Gecko International Co.						DATE	2026-4-21	DIMENSION	TOLERANCE
TITLE	PUSH-IN RIVET					SCALE	FIT	L ≤ 4	±0.10
ARTICLE NO.	GRS85	MOLD NO.	S0555/556/569/701	DRAW	PLK	UNIT	MM	4 < L ≤ 15	±0.20
PART NO.	SEE TABLE	MATERIAL	SEE NOTES	DESIGN	PLK	VERSION	A1	15 < L ≤ 50	±0.30
DWG NO.	E2190	COLOR	SEE TABLE	APPROVAL	FDL	VIEW		50 < L ≤ 100	±0.40

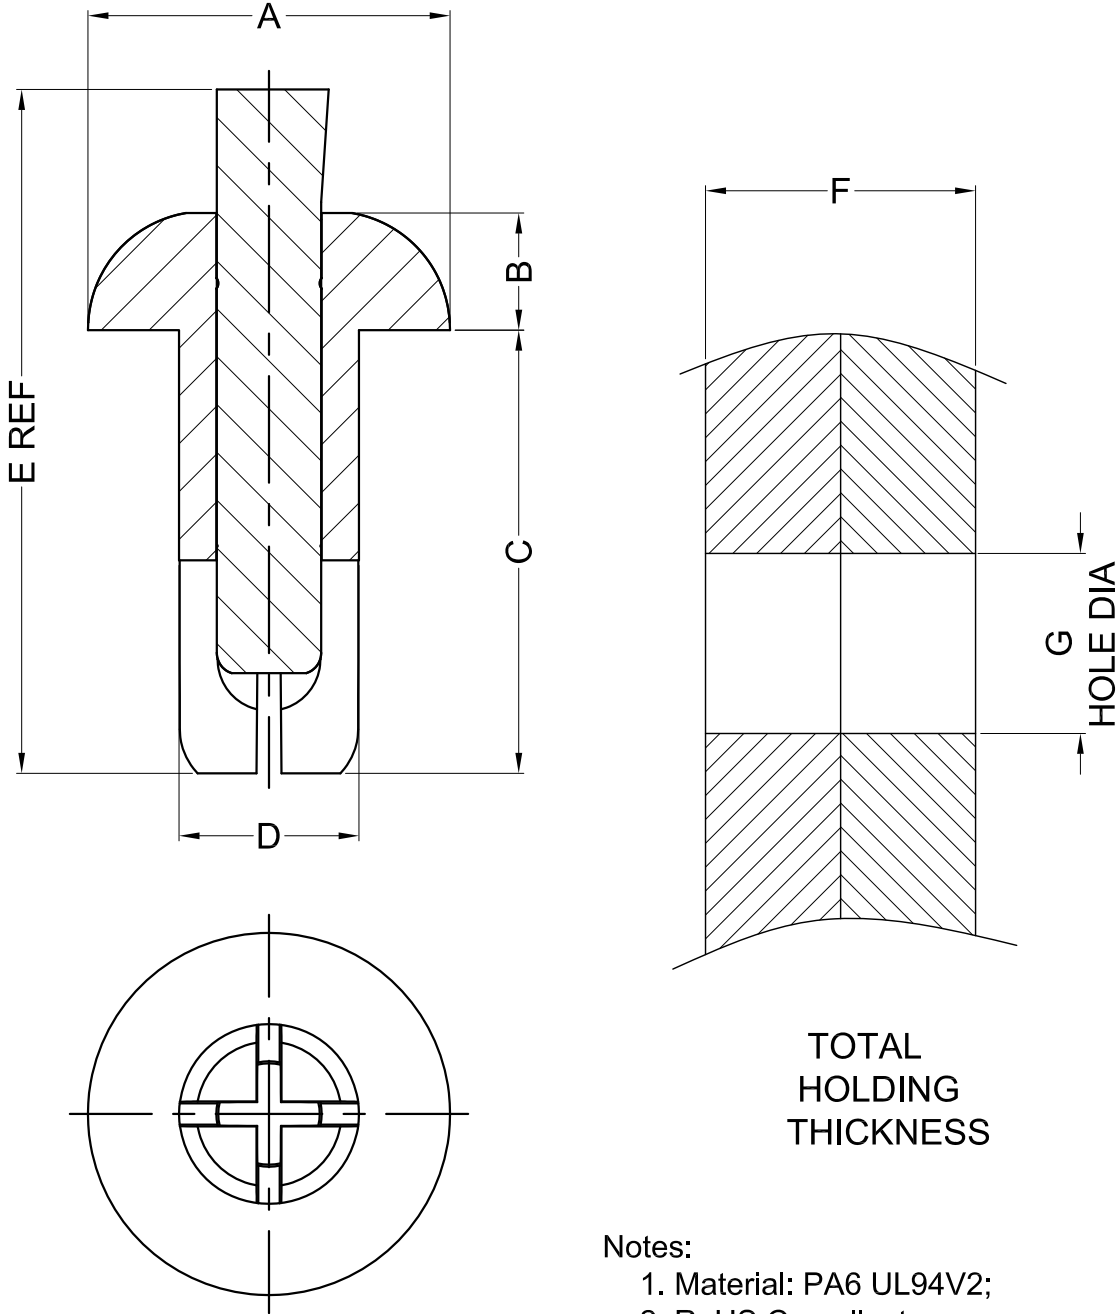
REV	DESCRIPTION	DATE	CHECK
A1	The panel thickness "F" changed from 6.0-9.0mm to 8.0-12.0mm. The panel thickness "F" changed from 11.5-14.5mm to 13.0-17.0mm.	2026-4-21	FDL
